SUBJECT: PD 05-016 AMENDMENT (WINERY ROW – HOSKINS)

DATE: AUGUST 11, 2009

Needs: To consider an application filed by Larry Gabriel, Architect, on behalf of Chris Hoskins to amend PD 05-016, the Airport Business Park, to allow for winery related uses.

# **Exhibit B** **Site Plan & Street Elev.** **PD 05-016 Amendment** **(Winery Row)**

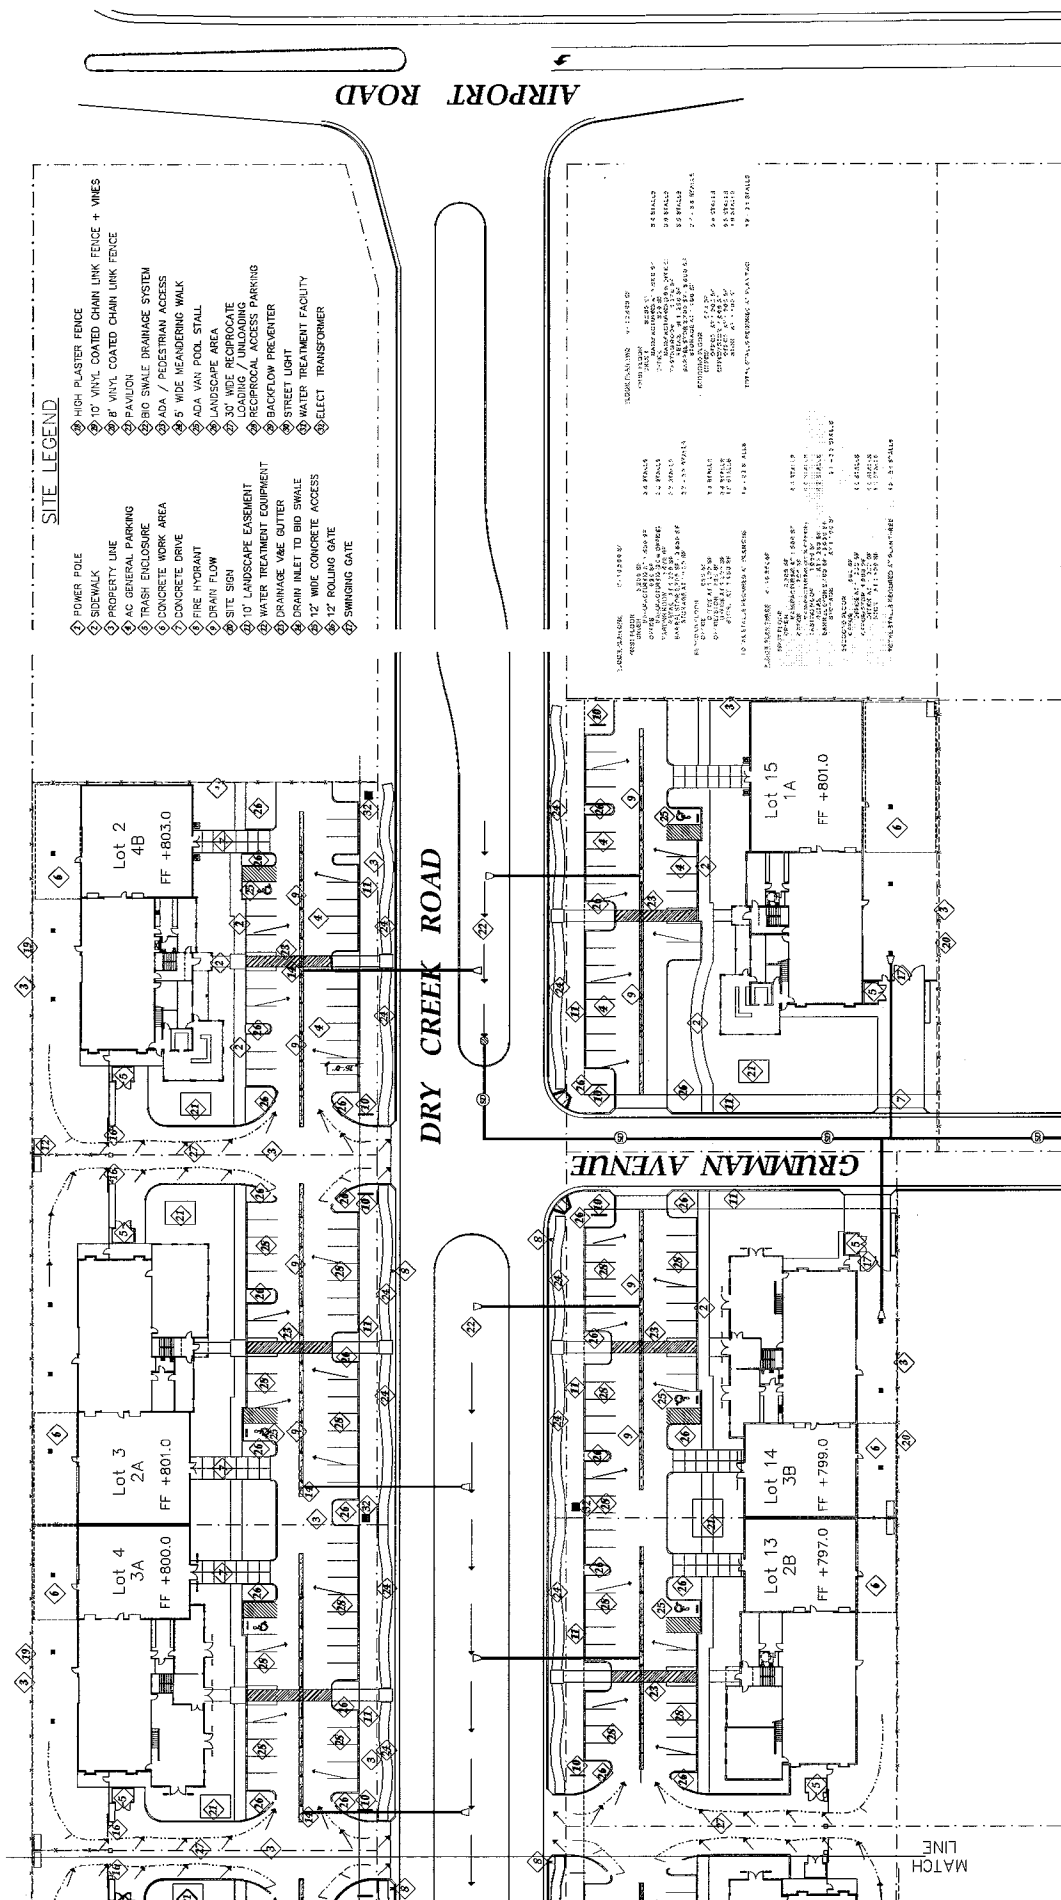
Buildings proposed on Lots 11 through 14 encroach into easements established with the recordation of Tract 2772. All lot owners in Tract 2772 must acknowledge quitclaim of these easements prior to issuance of building permits.

Dry Creek Road has been developed as an Arterial Street in Tract 2772 consistent with the circulation element of the General Plan. A center landscape median has been provided. The proposal to develop wineries open to the public will generate pedestrian traffic that was not considered in the context of a business park. Improvements should be made to accommodate and encourage pedestrian traffic. A plan of sidewalks and a cross-walk across Dry Creek Road should be provided.

Prior to issuance of building permits, easements conflicting with proposed buildings must be quitclaimed by all holders of interest

Prior to occupancy of building permits on the south side of Dry Creek Road, a plan of sidewalks including a decorative cross-walk across Dry Creek Road shall be submitted to the City Engineer for approval.

## **ADJ. ELEVATIONS - SOUTH SIDE**

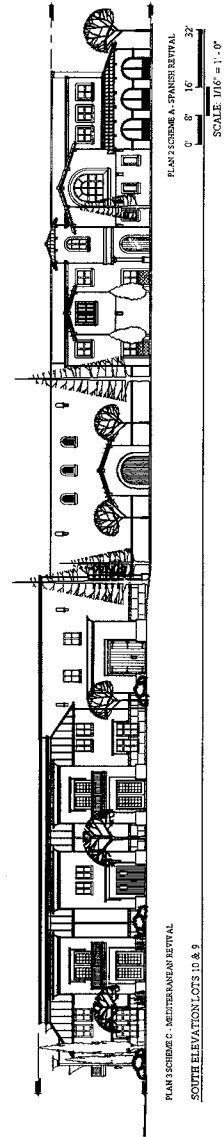
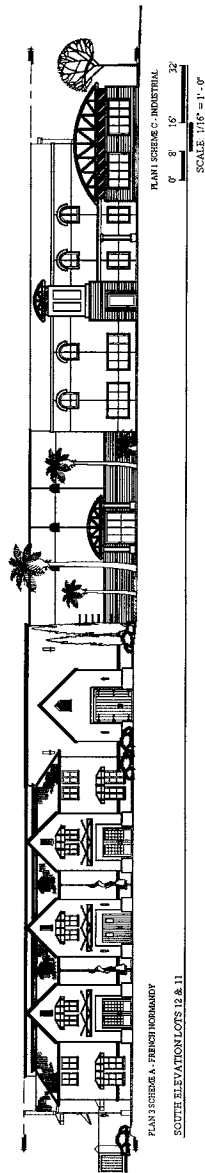
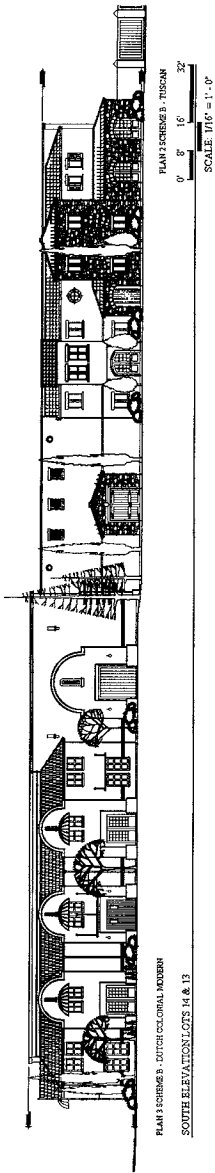
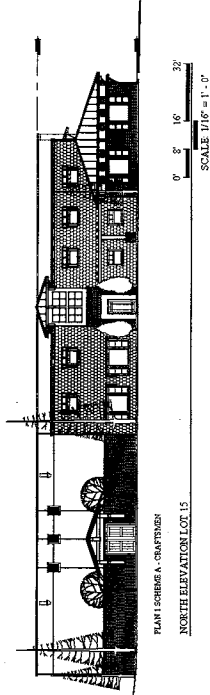
1. Four sided architecture:  
We have included the rear elevations for Lots 13, and 14.  
These are representative of the typical rear elevations for the 7 Lots on the south side of Dry Creek Road; see South Elevations on Sheet 10.
